SUBJECT: Removal Action Report (RAR) for the C-Area Groundwater (CAGW) Operable Unit (OU) Bio-Barrier Non-Time Critical (NTC) Removal Action (U) (SRNS-RP-2019-00584, Revision 1, June 2020) (Redline Pages and Clean Copy) and the Savannah River Site's Responses to the Regulatory Comments on the Revision 0 Document, SEMS Number: 82

SRS Responses to EPA Comments on the Removal Action Report for the C-Area
Groundwater Operable Unit Bio-barrier Non-time Critical Removal Action SEMS
Number: 82, SRNS-RP-2019-00584, Revision 0, December 2019, Savannah River Site,
South Carolina

Figure 4. CAGW OU Pre-Remedial Action Site Plan

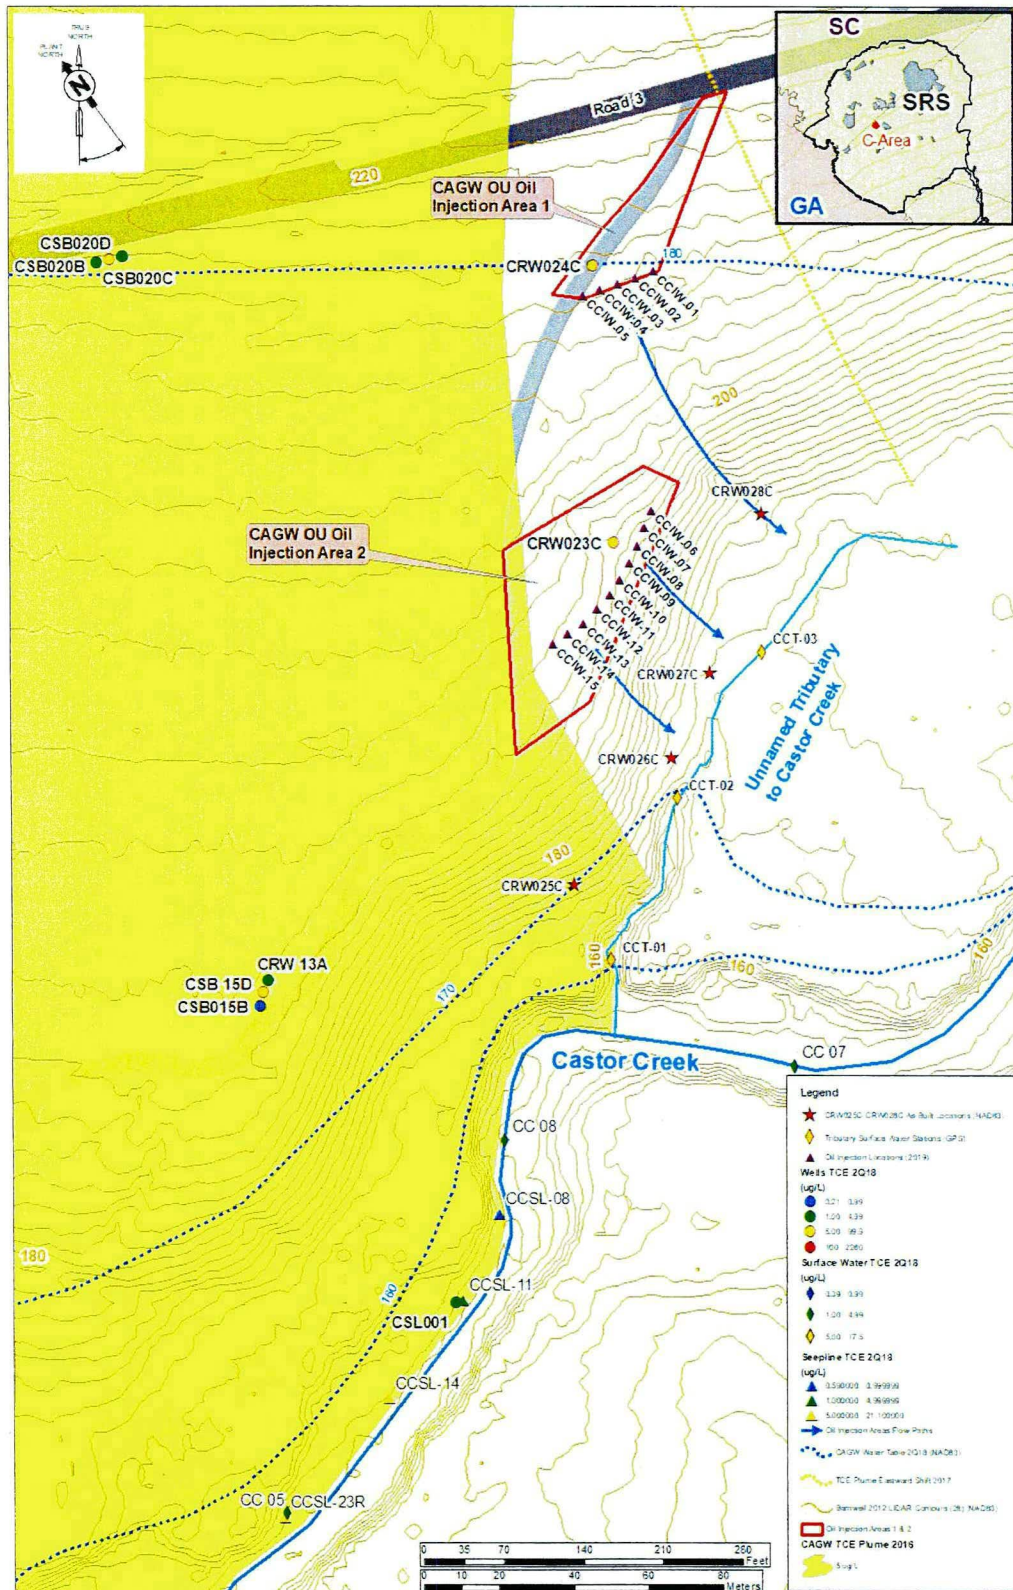
5. Figure 4, CAGW OU Pre-Removal Action Site Plan

Revise Figure 4 to include groundwater flow direction.

Response: Agree.

Figure 4 (attached) was revised to include groundwater flow directions and will be included in the revised RAR.
